**Amendment No. 5****16-11-2017****Sub: Amendment to the Bidding Document**

**Ref.: Notice Inviting Bid ref. HITES/PCD/NCI-AIIMS/02/17-18 dated 14.09.2017 read with its Amendment No. 1, Amendment No. 2, Amendment No. 03 and Amendment No. 04 dated 25.10.2017, 27.10.2017, 03.11.2017 and 14.11.2017 respectively.**

**SECTION - VII****TECHNICAL SPECIFICATION AND GENERAL POINTS****A. TECHNICAL SPECIFICATION****Item sl. no. 01****3.0 TESLA MR SCANNER**

**PROJECT**  
 NCI - AIIMS  
 AT JHAJJAR  
 HARYANA

**TITLE**  
 WORKING DRAWING  
 BASEMENT PLAN

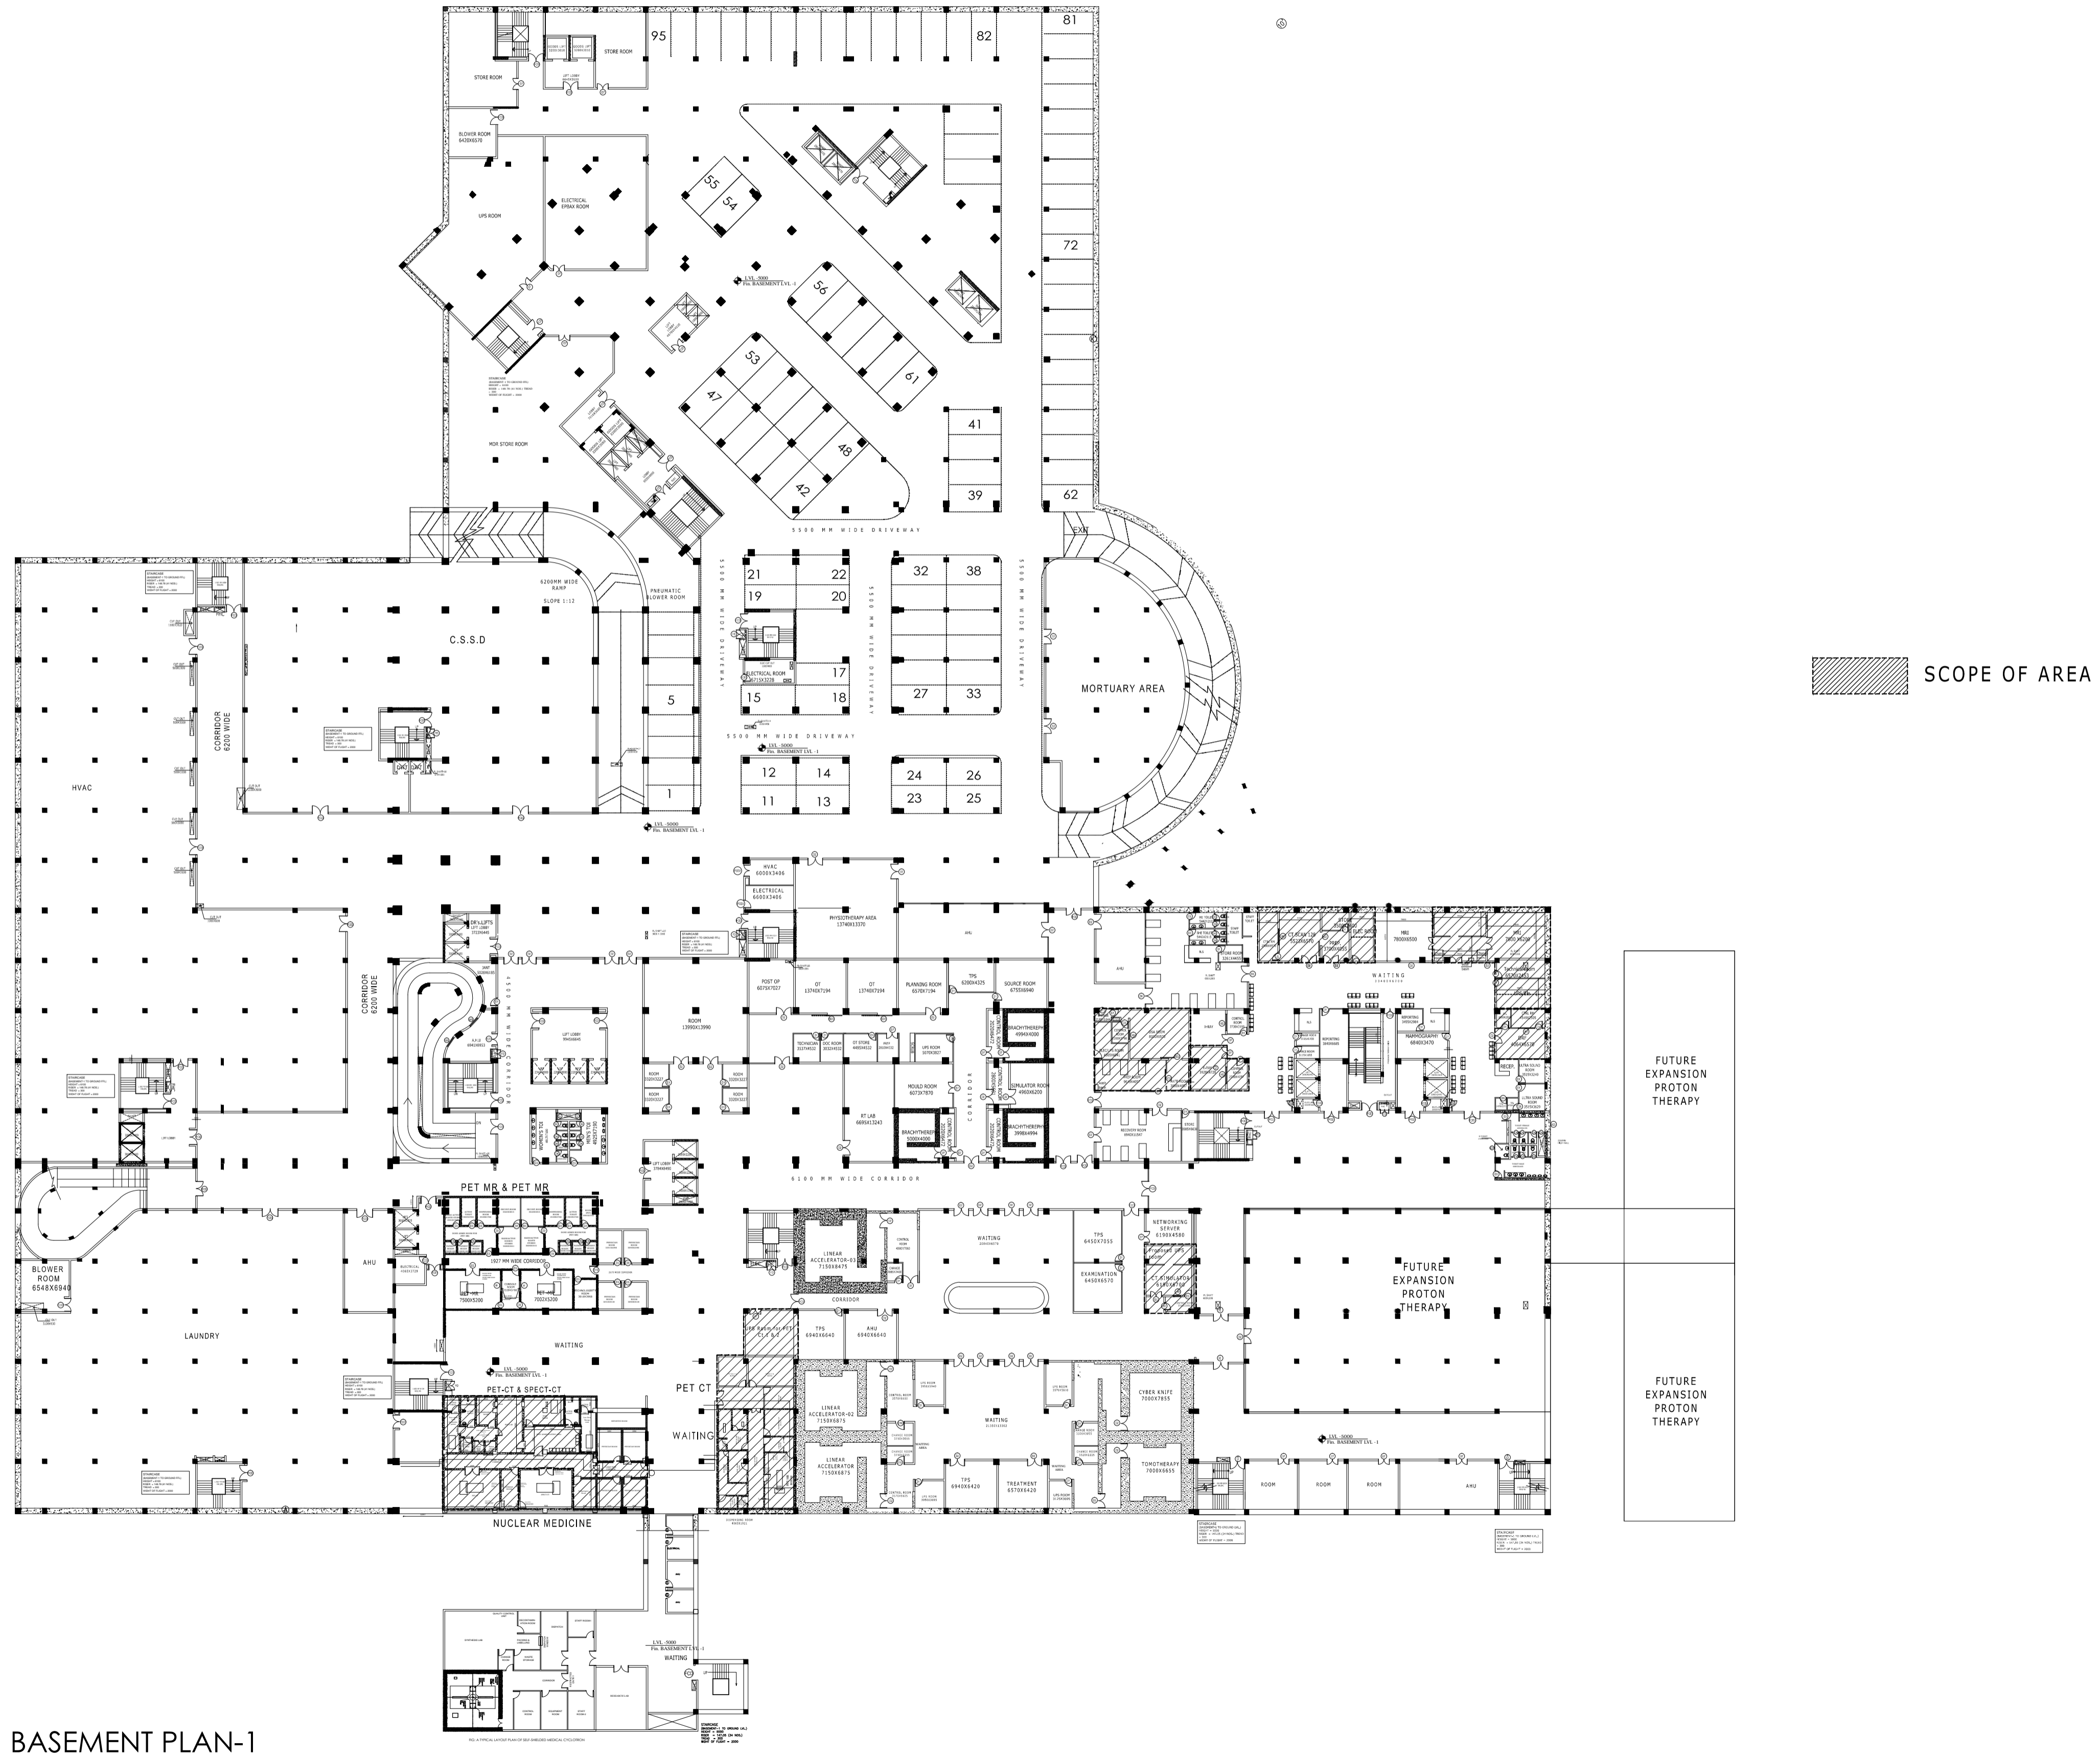
Revised site plan showing the location of the radiology equipment, as well as site modification area is attached in the following 2 pages for reference.
